Access Compliance Report

Intersection ID: 10037049	Main Street: S_TRYON_ST	Cross Street: N/A	Location: SW
ADA ID: B9418150E95D	Ramp Type: BlendTrans2	Initial Pass/Fail: Fail	Overall Compliance: No
Severity Score: 25			
Codes/Mitigation Info/Possible Solution		Field Measurements/Component Compliance

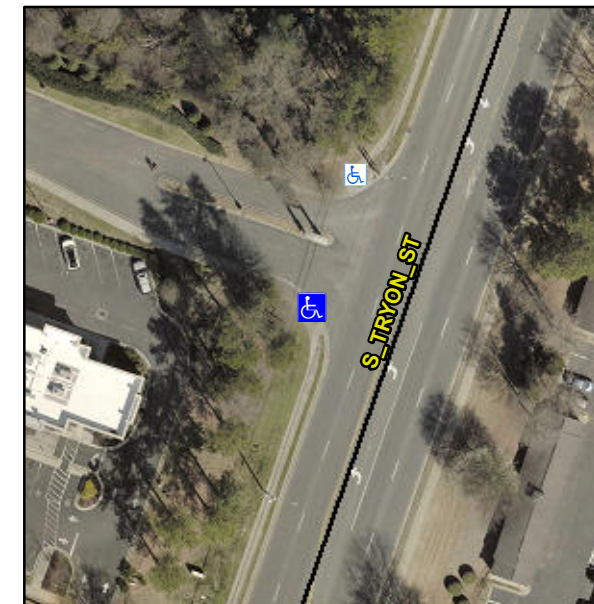
Possible Solutions:

Remove & Replace Curb Ramp With Two New Directional Ramps or Equivalent.

R304.5.3

Compliance	Description	Data	Compliance	Description	Data
N/A	Ramp Length (in)	89.0	Yes	BlendTrans Slope (%)	2.8
Yes	Ramp Width (in)	57.0	No	BlendTrans XSlope (%)	8.2
N/A	Flare Type LT	N/A	N/A	Flare Type RT	N/A
N/A	Flare Slope LT (%)	N/A	N/A	Flare Slope RT (%)	N/A
N/A	Flare Traversable LT?	N/A	N/A	Flare Traversable RT?	N/A
N/A	Landing Length (in)	N/A	N/A	DWS Provided?	N/A
N/A	Landing Width (in)	N/A	N/A	DWS Contrast?	N/A
N/A	Landing Slope (%)	N/A	N/A	DWS Length (in)	N/A
N/A	Landing X Slope (%)	N/A	N/A	DWS Full Width?	N/A
N/A	Landing Curb? (Y/N)	N/A	N/A	DWS Offset (in)	N/A
N/A	Shared Landing?	N/A			
N/A	Gutter Ponding?	N/A	N/A	Gutter Slope (%)	N/A
N/A	Gutter Lip Ht (in)	N/A	N/A	Gutter X Slope (%)	N/A
N/A	Painted X Walk1?	No	N/A	Painted X Walk2?	No
	X Walk 1 Direction	To E		X Walk 2 Direction	To N
	X Walk 1 Width (in)	N/A		X Walk 2 Width (in)	N/A
	X Walk 1 Slope (%)	4.1		X Walk 2 Slope (%)	1.3
	X Walk 1 X Slope (%)	0.1		X Walk 2 X Slope (%)	2.9
